From: David Karger [<mailto:karger@mit.edu>]  
Sent: Friday, February 02, 2018 12:20 AM  
To: Strysky, Alexander (EEA); [comments@walkboston.org](mailto:comments@walkboston.org)  
Subject: I-90 Allston, EEA # 15278

I-90 Allston Interchange project  
Draft Environmental Impact report

**From:** Stephen Paul Linder [<mailto:stephen.linder@gmail.com>]  
**Sent:** Saturday, February 03, 2018 7:06 PM  
**To:** Strysky, Alexander (EEA)  
**Cc:** [advocacy@thecharles.org](mailto:advocacy@thecharles.org)  
**Subject:** Reconstruction of the Mass Pike in Allston

**FIGURE  
3.3-4**

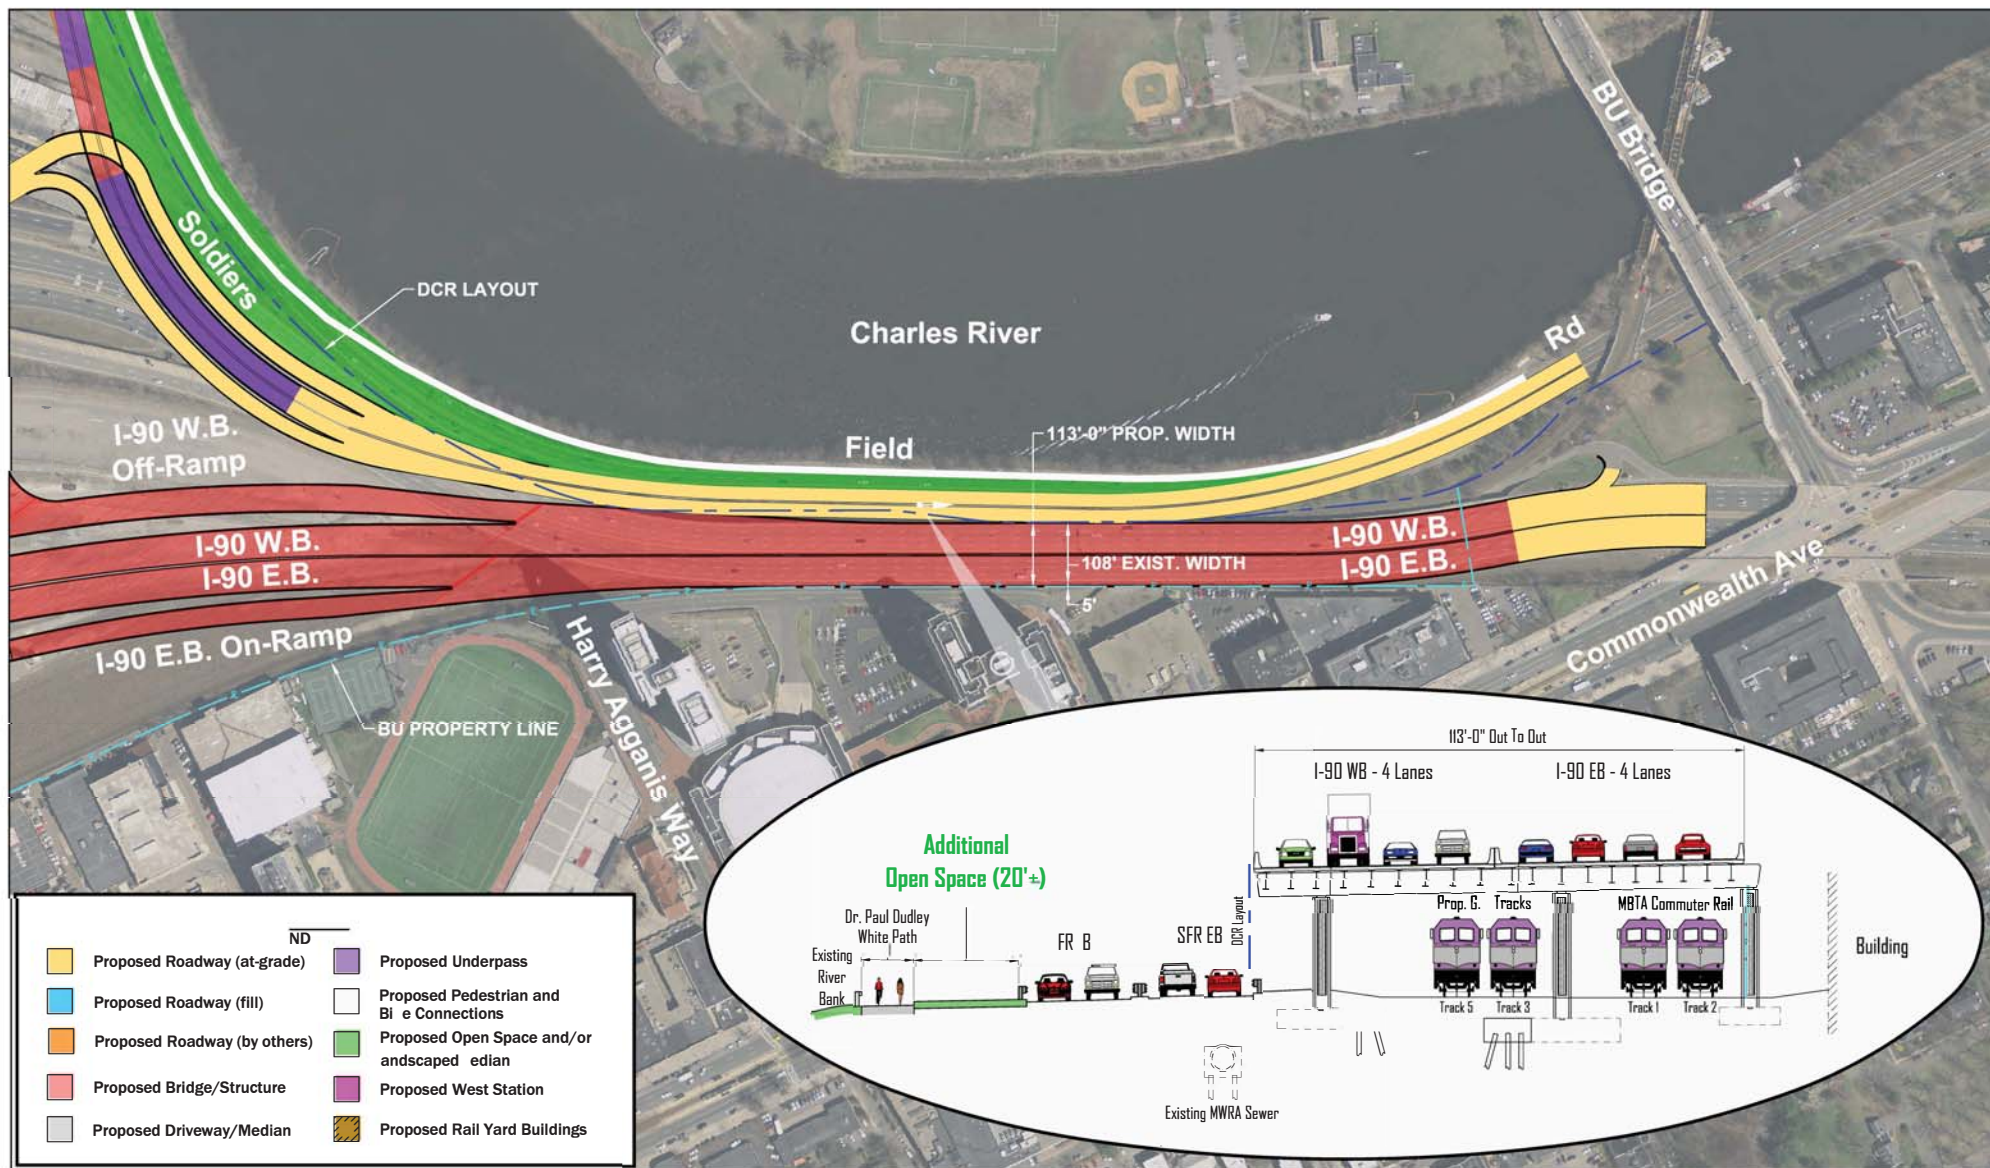
I am writing in support of all the points contained in Henrietta Davis's letter (attached) regarding the I90 project in Allston. In addition, I would like to emphasize two of them. First, noise from the present turnpike in the "throat" area is unacceptably loud and any future rebuild of the turnpike should reduce the noise heard in Cambridge. Second, the space allotted the Paul Dudley White pedestrian and bike path in all three throat options is too small. The highways (Turnpike and Soldiers Field Road) should be made as narrow as possible to increase the space available for this important riverside path. I was surprised to see in the DEIR that a highway viaduct option (HV-4, cross section view from DEIR attached), ultimately rejected, actually created 20 more feet of right of way for the Paul Dudley White path. HV-4 should be reconsidered as should limiting the turnpike to 6 lanes through this narrow area.

RB-1 see HD
